## Product Change Notification / SYST-27XBYV713

ERRATA - dsPIC33EPXXXGM3XX/6XX/7XX Errata Document Revision

## dsPIC33EPXXXGM3XX/6XX/7XX Family Silicon Errata and Data Sheet Clarification

The dsPIC33EPXXXGM3XX/6XX/7XX family devices that you have received conform functionally to the current Device Data Sheet (DS70000689D), except for the anomalies described in this document.

**FIGURE 1: TIMING DIAGRAMS FOR CENTER-ALIGNED AND EDGE-ALIGNED MODES**

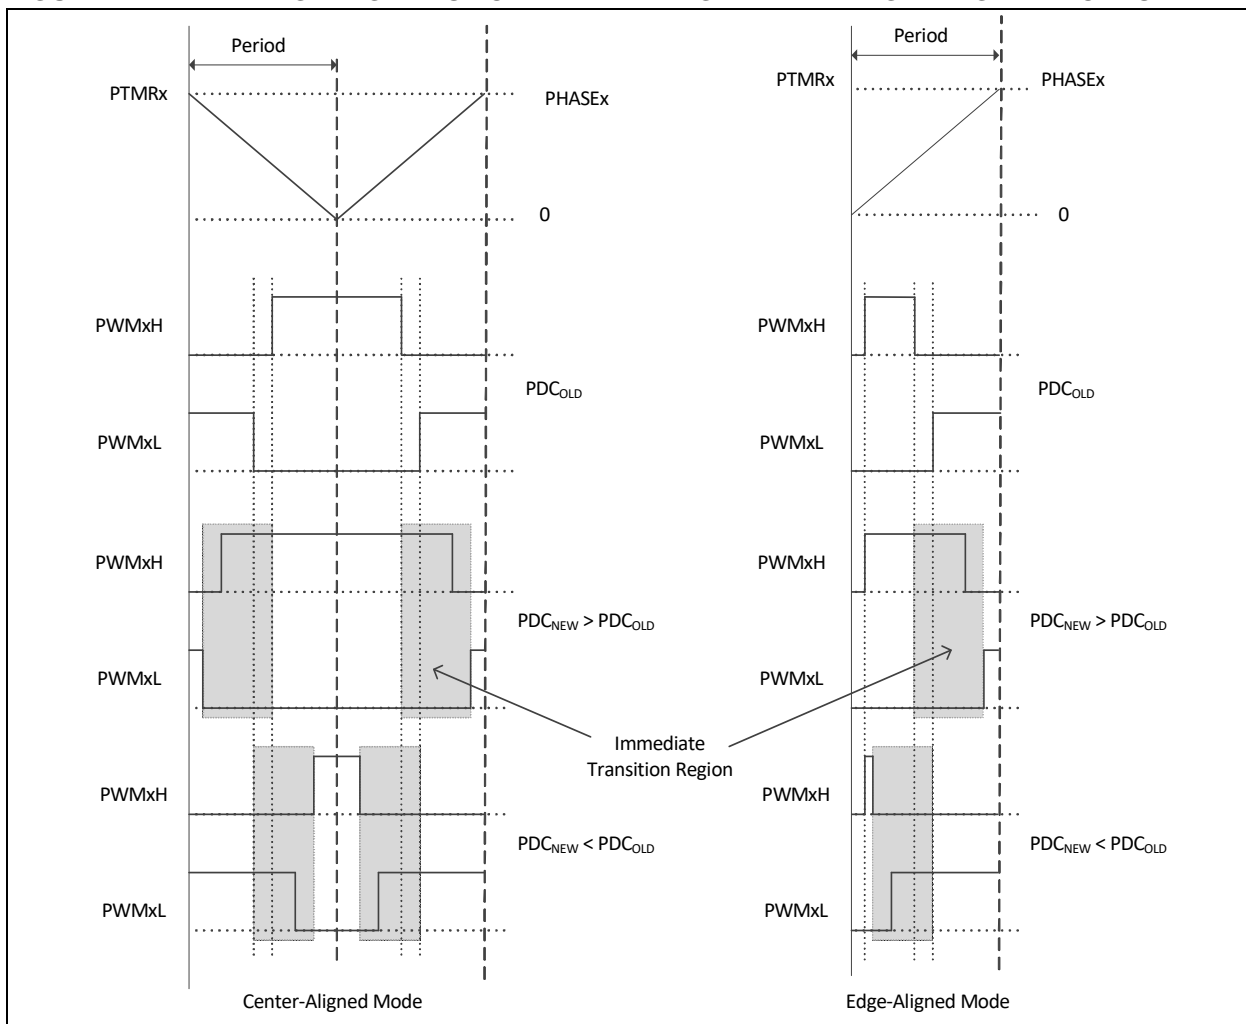
The PWM generator may not assert dead time on the edges of transitions. This has been observed when all of the following conditions are present:

- The PWM generator is configured to operate in Complementary mode with Independent Time Base (ITB) or master time base;
- Immediate update is enabled; and
- The value in the PDC register is updated in such a manner that the PWMxH and PWMxL outputs make an immediate transition.

In **Figure 1**, if the duty cycle write occurred in the shaded box, then PWMxH and PWMxL will make an immediate transition without dead time.

In most applications, the duty cycle update timing can be controlled using the TRIGx trigger, or Special Event Trigger, such that the above mentioned conditions are avoided altogether.

**FIGURE 2: PWM GENERATOR TIMING DIAGRAM**

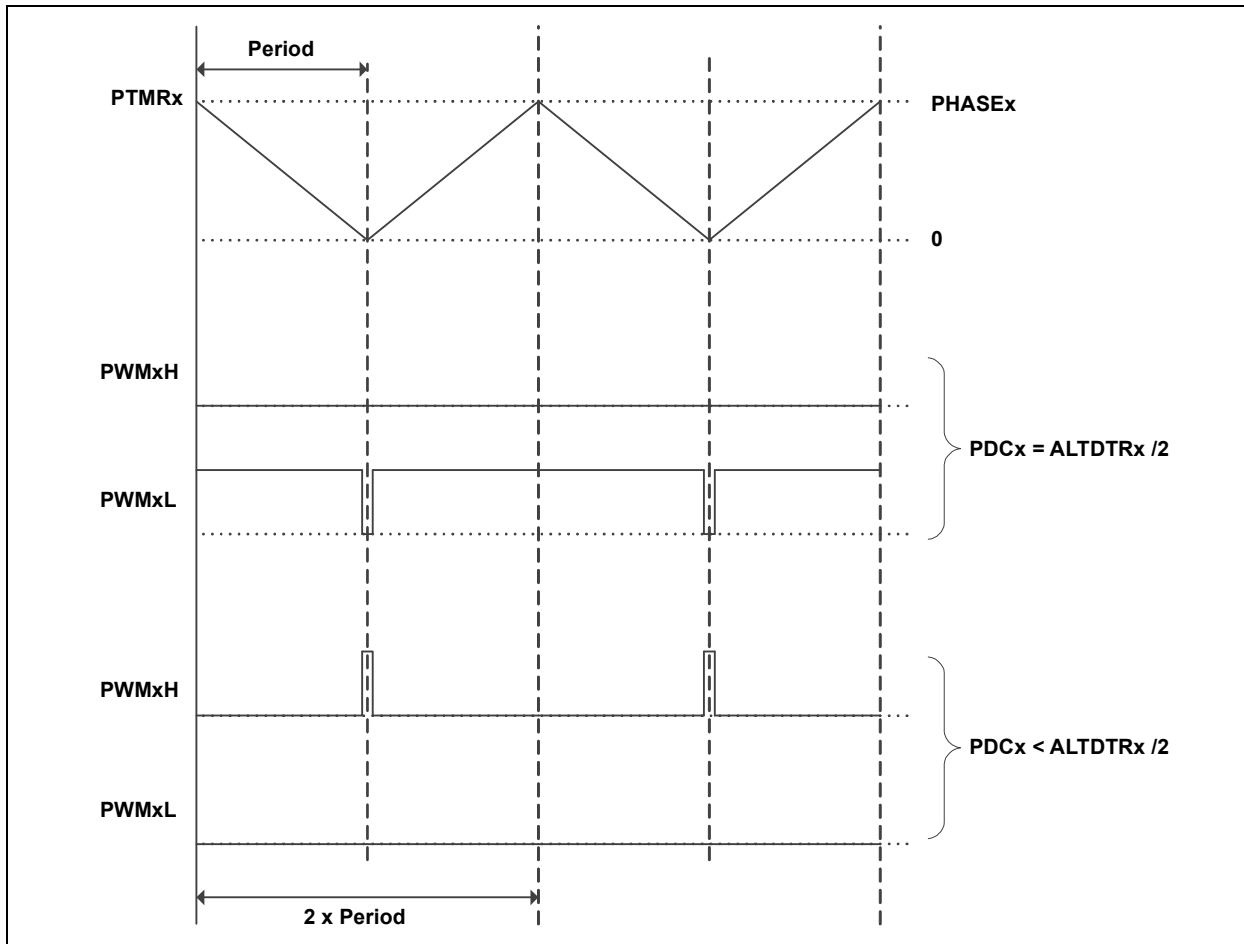
In Center-Aligned Complementary mode with Independent Time Base, if the value in the PDCx register is less than one-half the value in the ALTDTRx register, the PWM generator will force the PWMxL to low, and on the PWMxH, generates pulses of a width less than twice the dead time, as shown in Figure 2.

Include a software routine to ensure that the duty cycle value written to the PDCx register is at least one-half of the value in ALTDTRx. Example 1 shows one method, with PDCtemp representing the variable which has the value to be written to the PDCx register. Alternatively, for duty cycle values less than half the desired dead-time value, zero out the ALTDTRx register or dynamically reduce the value in the ALTDTRx register, such that ALTDTRx is always equal to  $2 * PDCx$ , as shown in Example 2.

**FIGURE 3:**

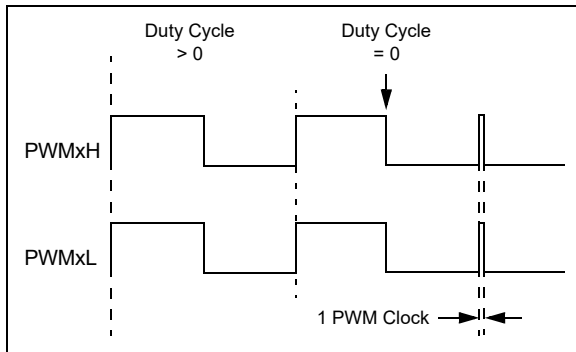
In certain output modes, the PWMx module produces a pulse glitch of one PWM clock in width (Figure 3). This has been observed only when all of the following are true:

- Either Redundant or Push-Pull Output mode is selected (IOCONx[11:10] = 10 or 01);
- Immediate Update is disabled (PWMCONx[0] = 0); and
- The value of the current Duty Cycle register (either the PDCx or MDC register, as determined by PWMCONx[8]) is updated to zero from any non-zero value.

The pulse glitch has been observed to occur at the beginning of the following PWM boundary period.

If the application requires a duty cycle of zero, two possible work arounds are available.

1. Use the PWM overrides to force the output to a low state, instead of writing a '0' to the Duty Cycle register. When using this method, the PWM override must be disabled when the duty cycle is a non-zero value. If output override synchronization is configured to occur on CPU clock boundaries (IOCONx[0] = 0), enabling and disabling the override must be timed to occur as closely as possible to the PWM period boundary.
2. Configure the module for Immediate Update (PWMCONx[0] = 1) before enabling the module. In this mode, writes to the Duty Cycle register have an immediate effect on the output. As with the previous work around, writes to the Duty Cycle register must be timed to occur as close to the PWM period boundary as possible in order to avoid distortion of the output.

**FIGURE 4:**

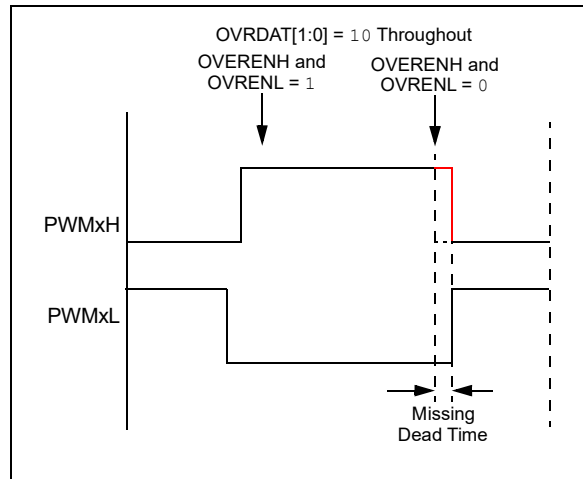
In Complementary Output mode, the expected dead time between transitions of the PWMxH and PWMxL outputs may not be asserted when the following occurs:

- Output override synchronization is configured to occur on the CPU clock boundary (IOCONx[0] = 0);
- Both PWMxH and PWMxL overrides are enabled prior to the event (OVRENH and OVRENL are both '1'), and
- Both overrides are disabled (OVRENH and OVRENL are both '0') at the instant the dead time should be asserted (Figure 4).

This has been observed in both Center-Aligned and Edge-Aligned modes.

FIGURE 5:

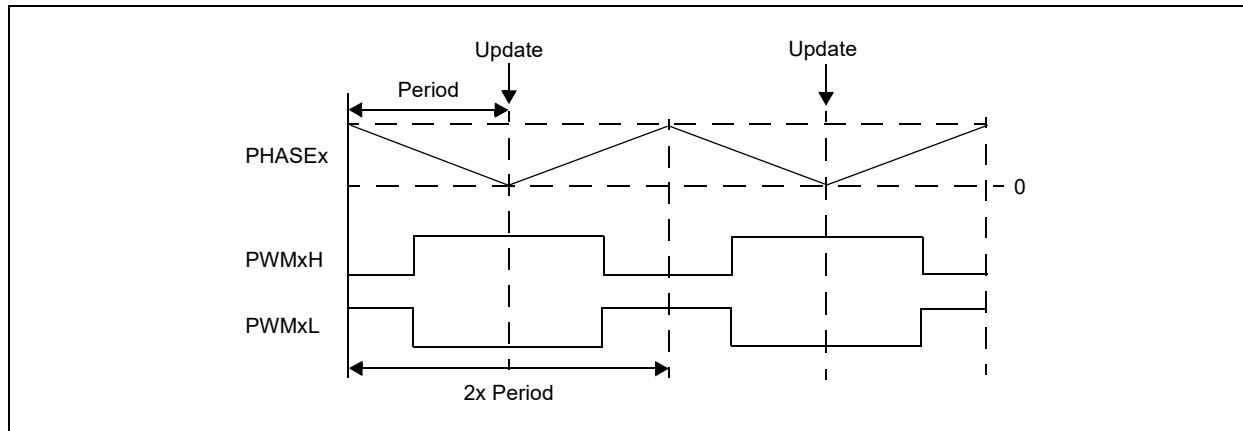
In Center-Aligned Complementary mode with Independent Time Base, updates to the PHASEx register take effect in the middle of a Center-Aligned PWM cycle, as shown in Figure 5. This occurs only when the Immediate Update feature is disabled (IUE = 0). If Immediate Update is enabled (IUE = 1), the PHASEx register updates will take effect immediately.

**FIGURE 6:**

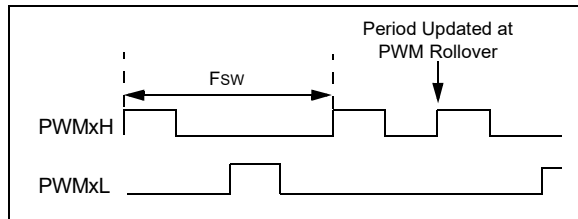
When the PWM module is configured for Push-Pull mode (IOCONx[11:10] = 10) with the Enable Immediate Period Update bit enabled (PTCON[10] = 1), a write to the Period register that coincides with the period rollover event may cause the push-pull output logic to produce back-to-back pulses on the PWMx pins (Figure 6).

Ensure that the update to the PWM Period register occurs away from the PWM rollover event by setting the EIPU bit (PTCON[10] = 1). Use either the PWM Special Event Trigger (SEVTCMP) or the PWM Primary Trigger (TRIGx) to generate a PWM Interrupt Service Routine (ISR) near the start of the PWM cycle. This ISR will ensure that period writes do not occur near the PWM period rollover event.

**FIGURE 7: SIMPLIFIED BEHAVIOR**

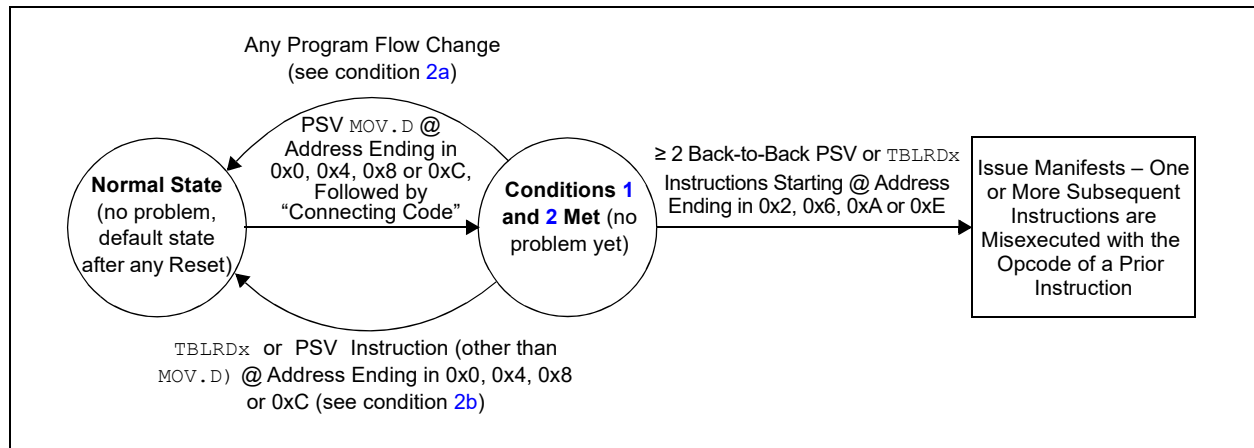
3.	≥ 2 back-to-back PSV or <code>TBLRDx</code> instructions are executed (following the code of condition 2), where the first of the back-to-back instructions is located at an address ending in 0x2, 0x6, 0xA or 0xE.

[Figure 7](#) provides an example of the effective behavior.

1. All instances of PSV `MOV.D` can be replaced with two PSV `MOV` instructions instead. Non-PSV `MOV.D` instructions acting on RAM/SFRs do not need to be modified; or
2. If not already present, a program flow change instruction (such as `BRA $+2`) can be inserted above back-to-back data Flash read sequences; or
3. Back-to-back data Flash read instruction sequences can be broken up by inserting a non-Flash read instruction (such as a `NOP`), in between the Flash read instructions; or
4. The alignment of the code can be shifted to avoid the required opcode location addresses.

C code built with MPLAB® XC16 Compiler Version 1.32, or later, implements the work around by default. However, if the application uses Assembly language routines, these should be manually modified to implement the work around. Additionally, if precompiled libraries are used, these should be built with XC16 Version 1.32 or later. For additional information, please visit: [www.microchip.com/erratum\\_psrds\\_psrds](http://www.microchip.com/erratum_psrds_psrds)

## 64-Lead Plastic Quad Flat, No Lead Package (MR) – 9x9x0.9 mm Body with 5.40 x 5.40 Exposed Pad [QFN]

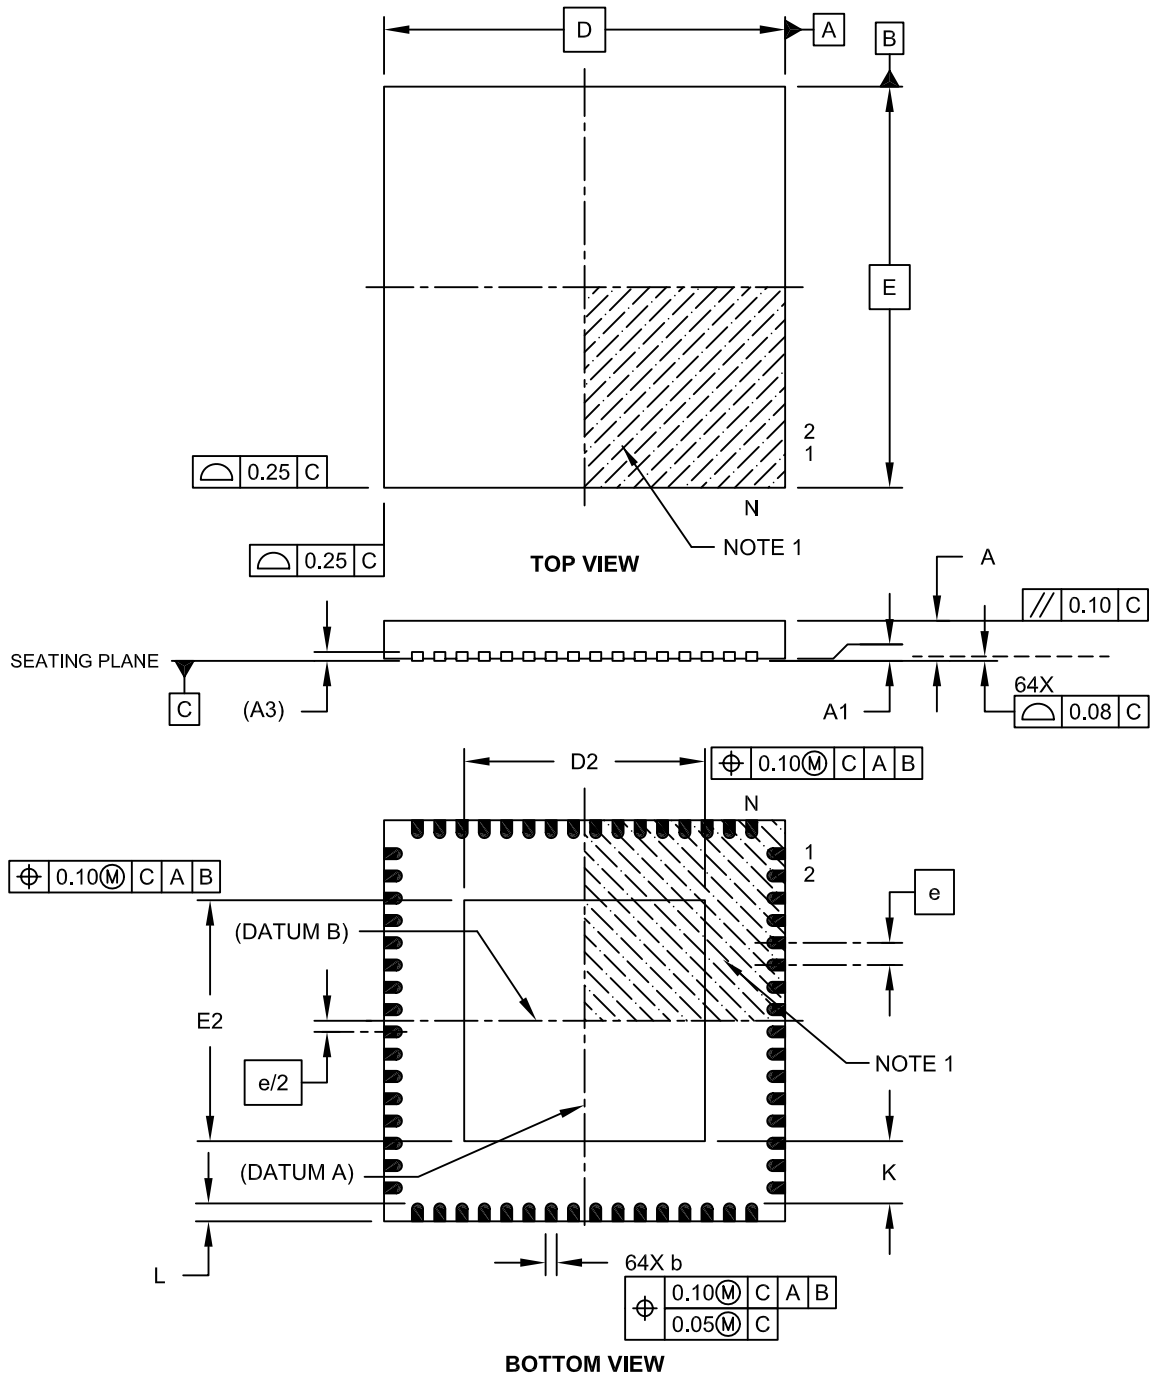
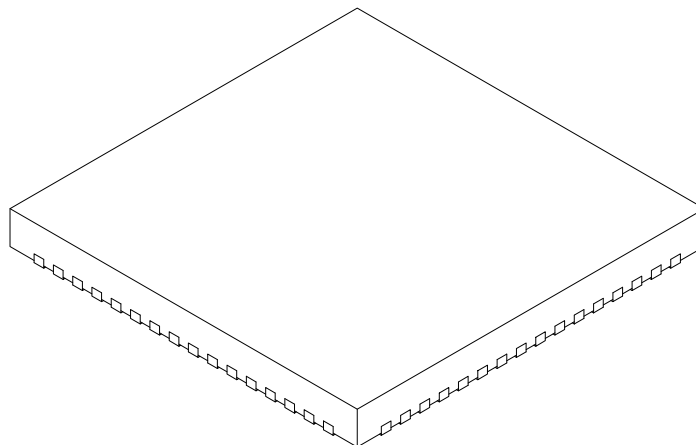
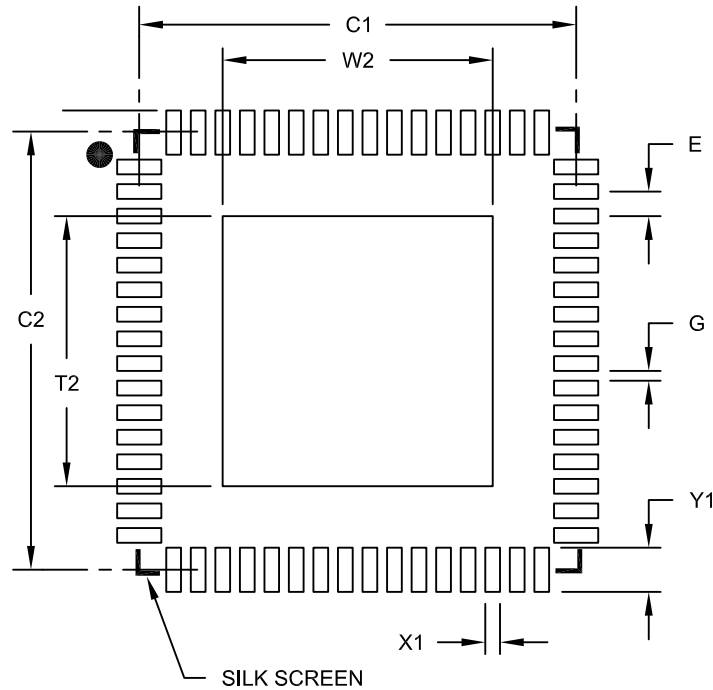
In the “*dsPIC33EPXXXGM3XX/6XX/7XX Family Data Sheet*”, **Section 35.2 “Package Details”**, dimensions for the 64-Lead Plastic Quad Flat, No Lead Package (MR) – 9x9x0.9 mm Body with 7.15 x 7.15 Exposed Pad [QFN] is mentioned. However, the dsPIC33EPXXXGM3XX/6XX/7XX family devices are not available in this package.

The dsPIC33EPXXXGM3XX/6XX/7XX family devices are available in the 64-Lead Plastic Quad Flat, No Lead Package (MR) – 9x9x0.9 mm Body with 5.40 x 5.40 Exposed Pad [QFN], and the package dimensions are shown on the following pages.
